**Report: PUNCHLIST
Function: Test, Adjust, & Balance
Date: 02/09/2026
Completed By: National TAB**

Platte City ASC NueHealth (Platte City, MO)

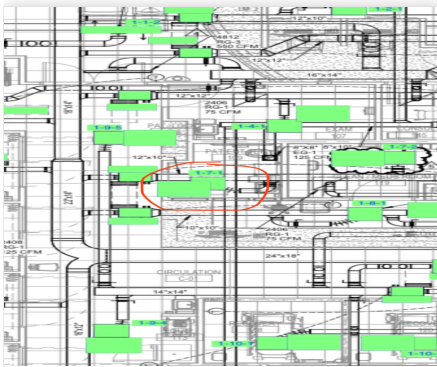
Issue Name : ORs: Missing Diffusers
Description : The diffusers in OR1 and OR3 are missing. Unable to Test/Balance airflows.
Created By : National TAB **Assigned To :** National TAB - Kalen Kemp
Status : Open
Priority : Urgent **Asset Tag :**
Originated Date : 02/10/2026 - Kalen Kemp - National TAB
